**Champlain Hudson Power Express ("CHPE")
Environmental Management & Construction Plan
Notice of Major Change**

Project: Champlain Hudson Power Express

Notice Number: 318

Drawing References: Segment 10 (Package 6) Appendix C: Sheets C-127, C-128, C-414

DRAWING NO.
C-414

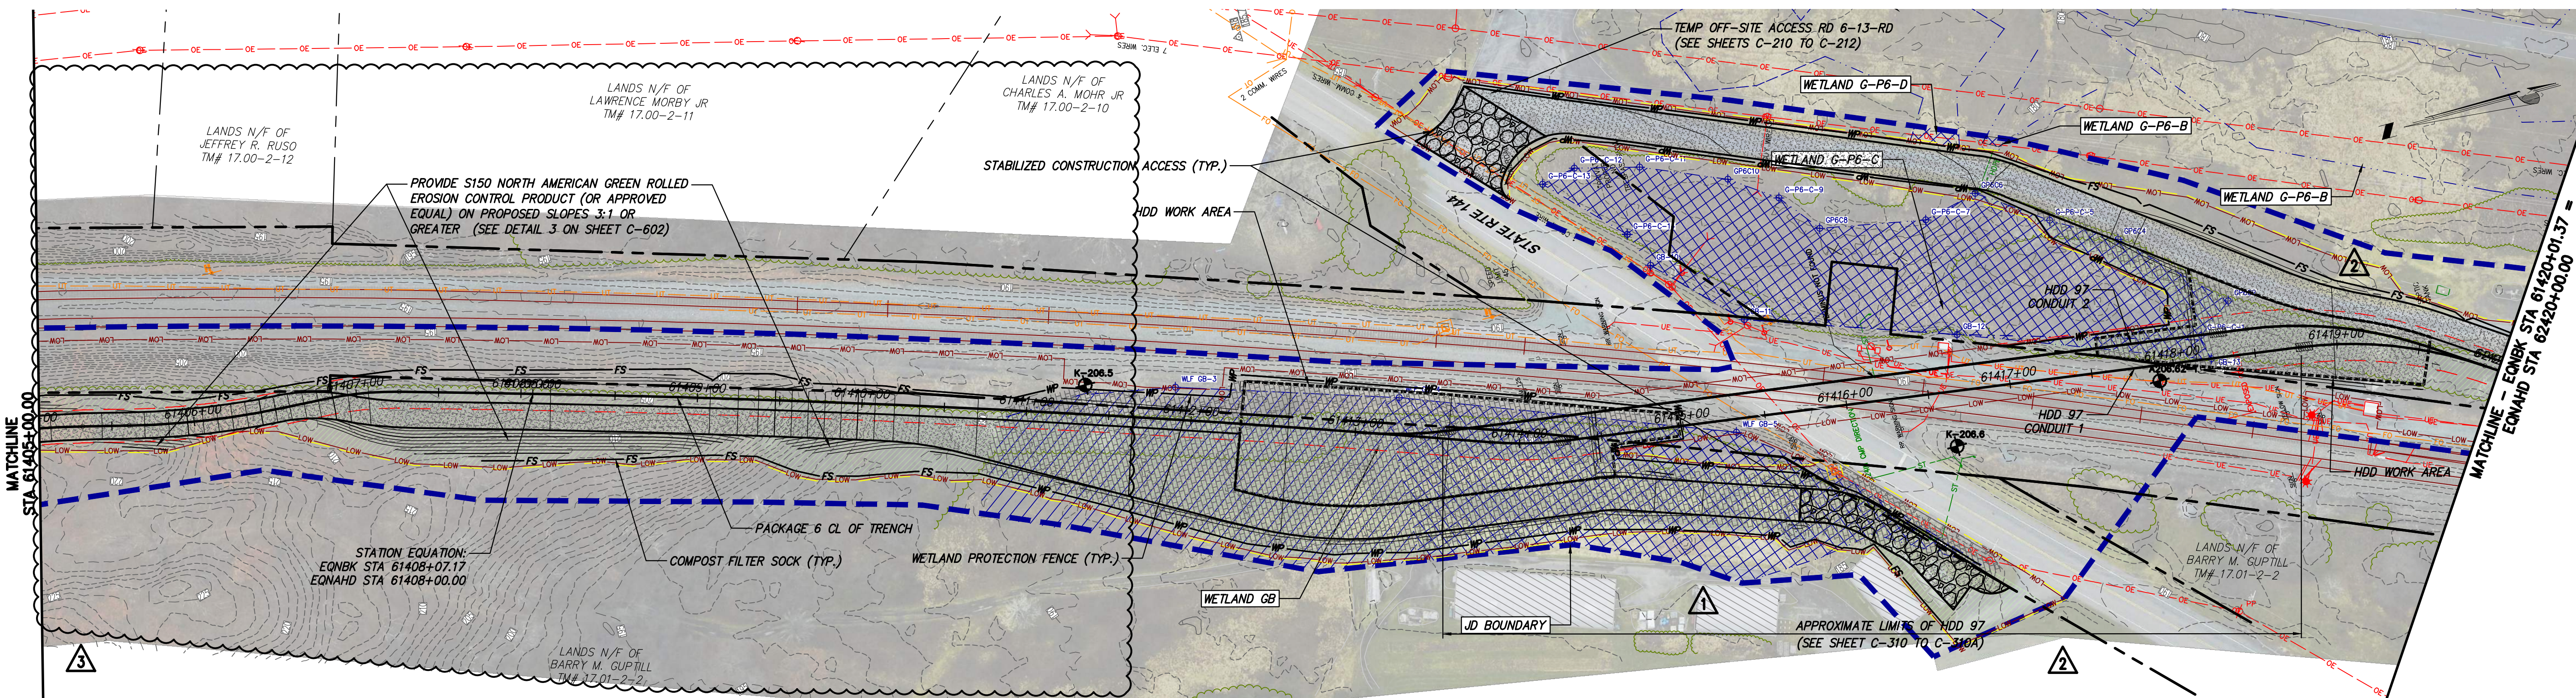
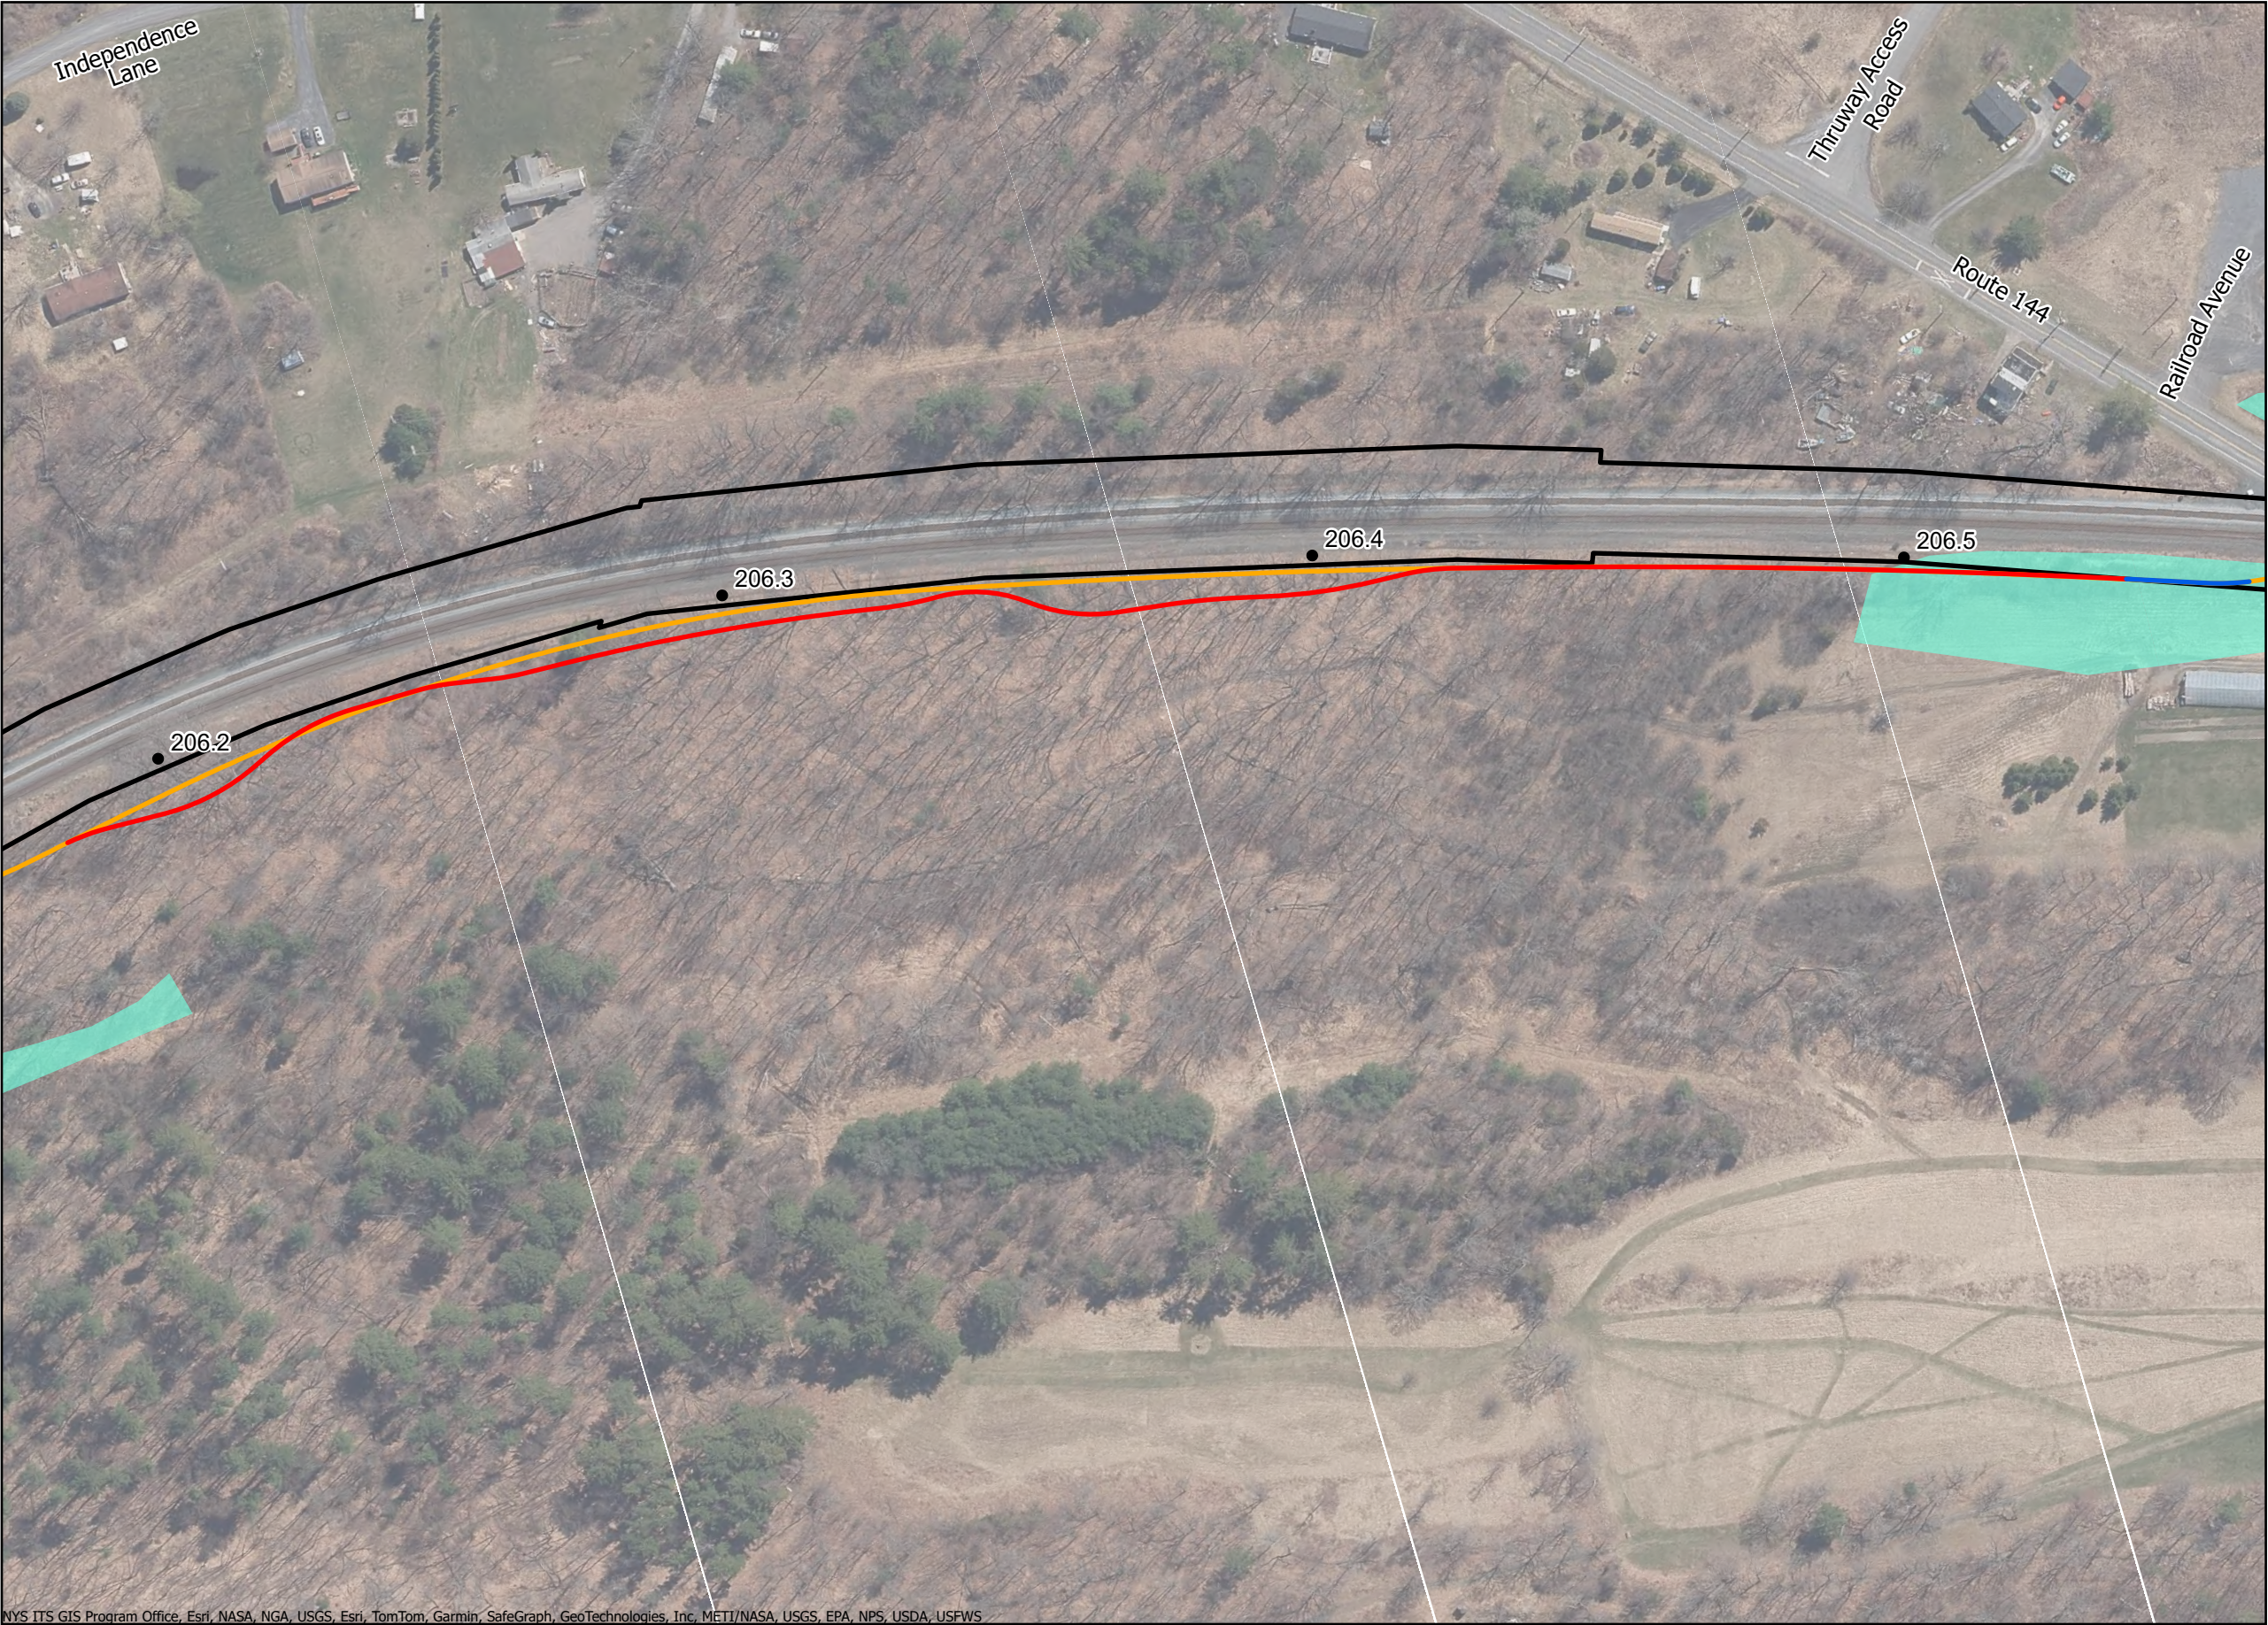
C-128	4	FDC-0083: WP-208 Alignment & Access Revisions	- Shifted alignment west from ~STA 61405+00 to ~STA 61407+10 to facilitate ductbank installation and minimize earthwork required for access. Revised alignment vertical profile, grading, and access road design accordingly. - Revised easement depiction to accommodate permanent alignment revisions. There are no changes to the approved limits of work (LOW) at these locations. - Added Station Equation 61408+07.17=61408+00.00 to plan and profile view.
C-414	3	FDC-0083: WP-208 Alignment & Access Revisions	- Sheet replot to capture permanent alignment, splice, and grading revisions from ~STA 61392+00 to ~STA 61407+00. Revised erosion and sediment (E&SC) controls accordingly. - Revised stabilized construction access design accordingly near ~STA 61395+00.
